## HARTING Product Change Notification

Business Unit: HARTING Customized Solutions PCN/20/012/PM+MD-US

Title: Modification of the Locking Nut for M12 PFT Products Page 1/3

#### **Details of the Product Changes**

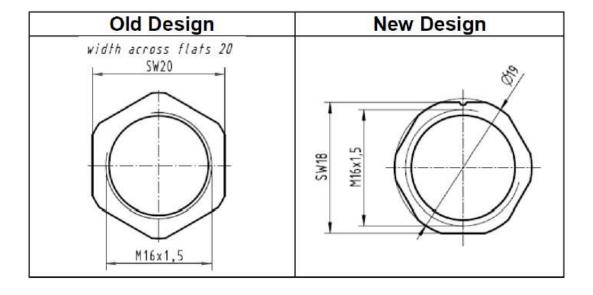
Width reduction of the lock nut flat area from 20 mm to 18 mm.

This change does not have an impact on fit, form or function of the products. A different assembly tool size needs to be selected to accommodate the new dimension.
